**Bureau of Environmental Health**

RECEIPT DATE: 8/2/18 **ONSITE SEWAGE DISPOSAL SYSTEM**P 563970APPROVAL DATE: 9/17/18 SEC **PERMIT: CONSTRUCTION**

PROPERTY ADDRESS: 1025 Thunderbird DriveSUBDIVISION: Fairlane FarmsLOT: 31 TAX ID: _____CONTRACTOR: South Carroll BackhoeEMAIL: scbackhoe@comcast.comCONTRACTOR ADDRESS: 4410 Salem Bottom Road, Westminster, MD 21157PHONE: 410-596-3618PROPERTY OWNER: NV Homes

SEPTIC SYSTEM
INSTALLATION SITE PLAN
LOT 31
1025 THUNDERBIRD DRIVE
FAIRLANE FARMS
PHASE TWO

SEPTIC SYSTEM INSTALLATION SITE PLAN LOT 31

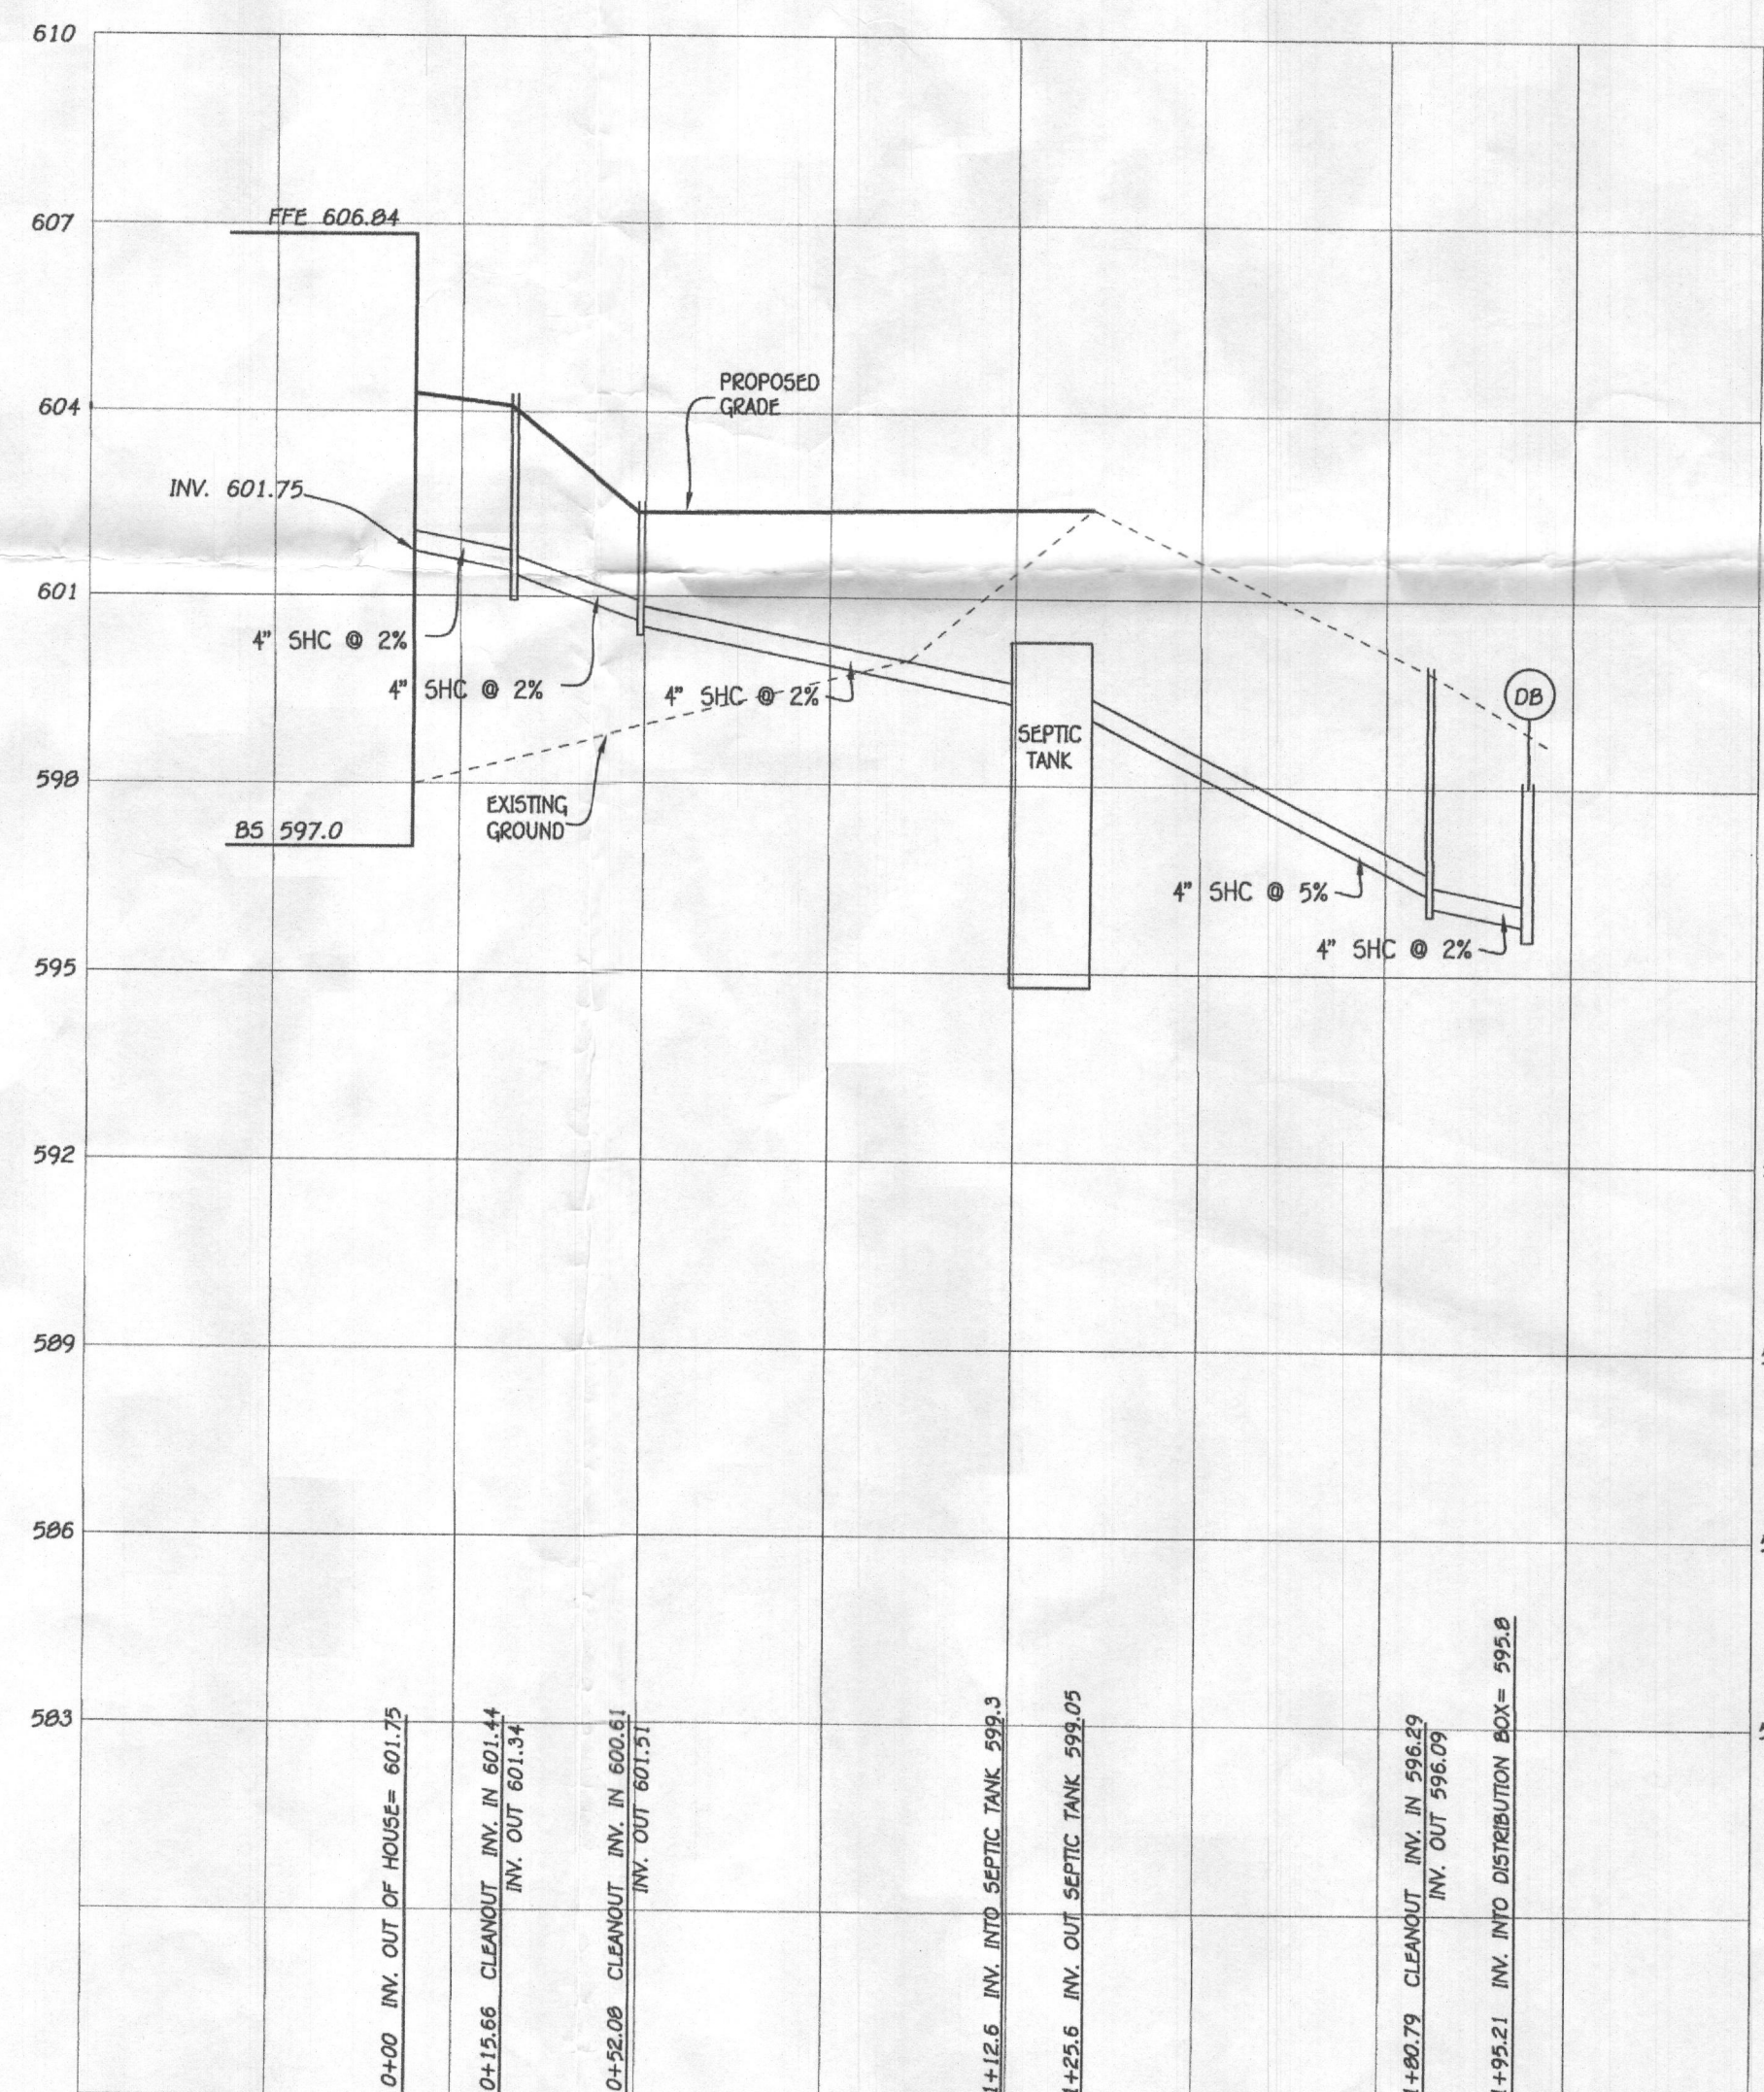
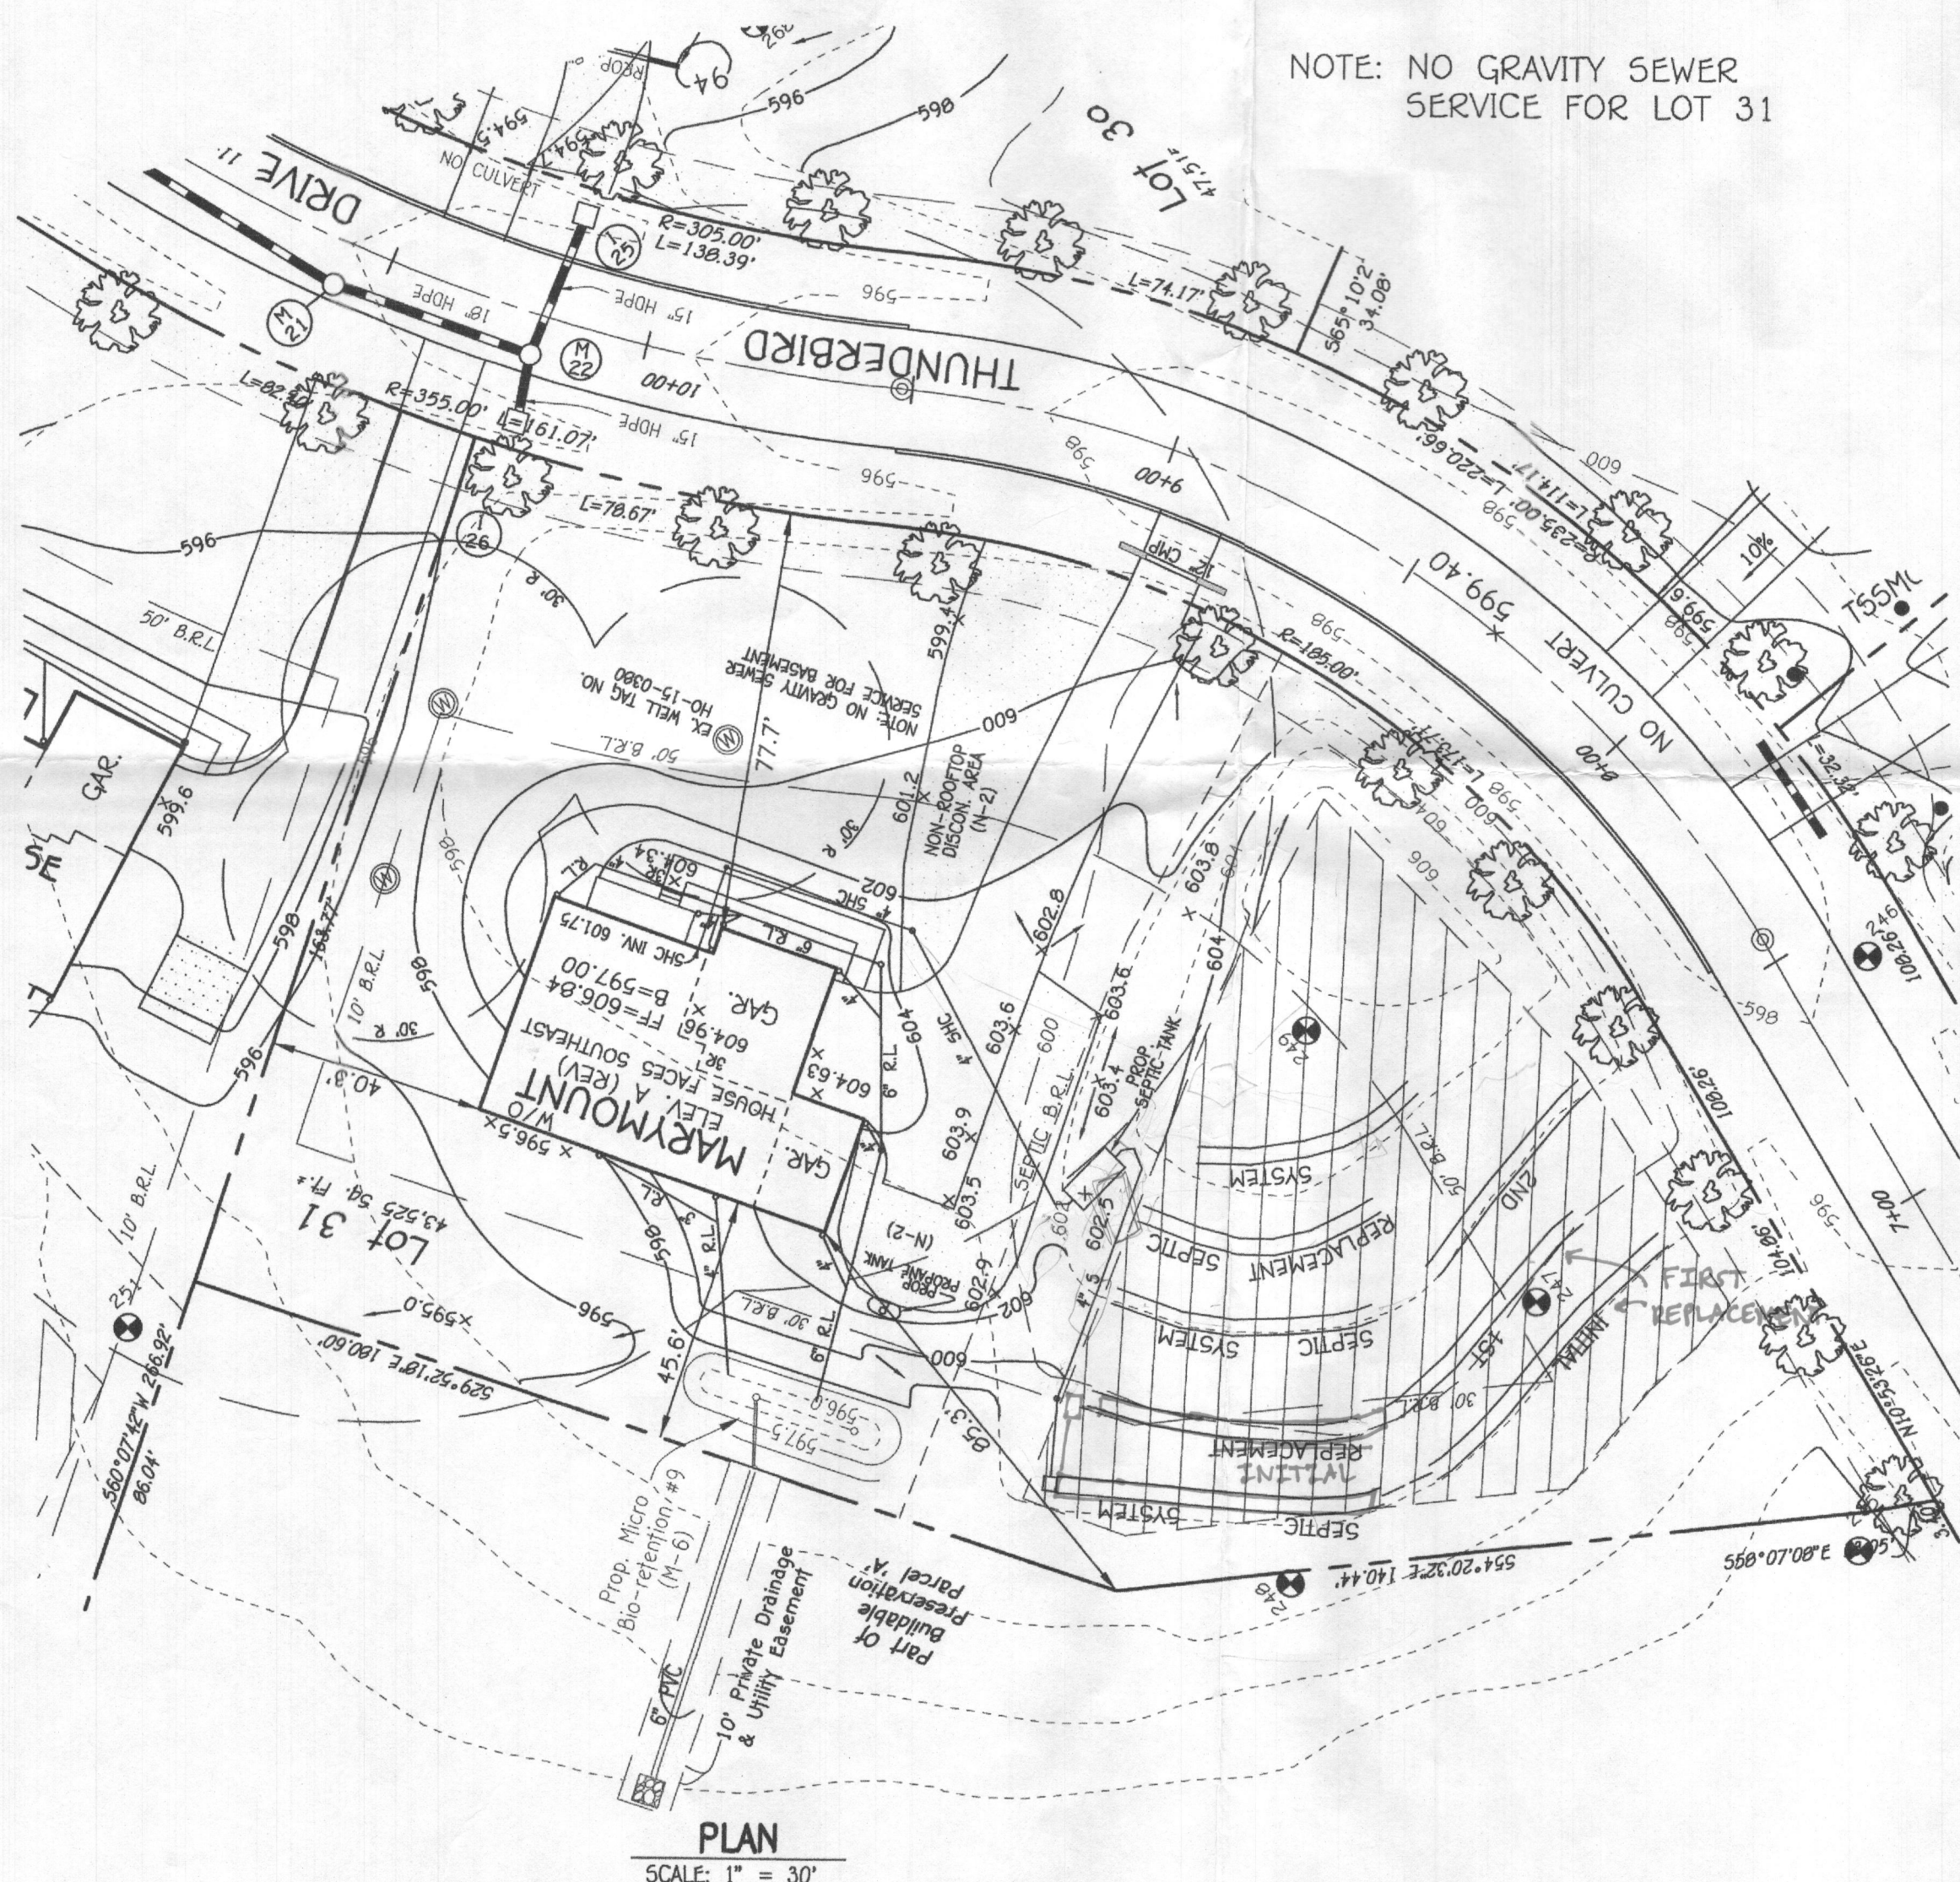
8/27/18 Met S. Carroll on site for layout. SDA corners + tank staked. OK to turn tank 90° to be in line with house sewer. Specs for initial system have a math error on septic plan - can have inlet 3', bottom 7.5', 120' total length. OK to install 2x60' trenches above perc hole #248 and move D-box uphill to start of T1. Shot contour + laid out 2x60' trenches. (SC)

INSTALLATION: 8/29/18 T1 dug, S. Carroll adding stone. 3' wide, 7.5' bottom. Measured inlet @ 4', should be 3'. Trench partially filled w/ stone + pipe, S. Carroll will raise 1'. [Corrective action.] On site while tank was set, no obvious cracks on bottom or sides of tank.

8/30/18 Trenches complete T2 left open for inspection + T1 left open @ ends. 3' wide, 7.5' to stone. [Corrective action completed.] Levelled speed levelers in D-box. Line run from house to tank, need house connection. (SC) 9/17/18 House connection made. Pictures sent from builder. (SC)
